Technical product information

Transmission: clutch pedal clacks

Transaction No.: 2018689/1

Release date: 25-Sep-2008

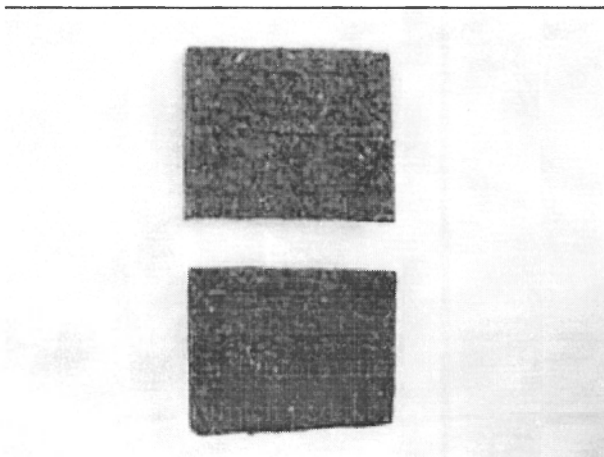
Noises (clacking) when operating clutch

Conflicting tolerance between pressure drawbar mounting and pressure drawbar of clutch master cylinder.

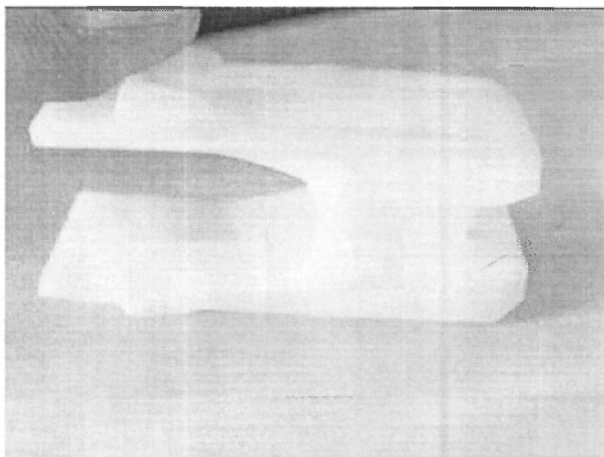
Cut 2 pieces of felt (part number: 533 867 910 A).

Length: 16mm

Cut the short side to about half the length (8mm).

Illustration shows relaxed condition

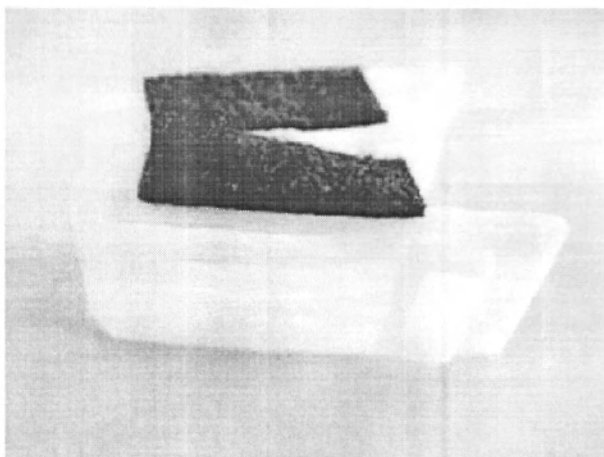
Press together the mounting (part number: 1K0 721 357 A).

bond the felt at 7mm distance on the pressed-together mounting.

Replace the treated mounting on the clutch pedal according to the repair manual.
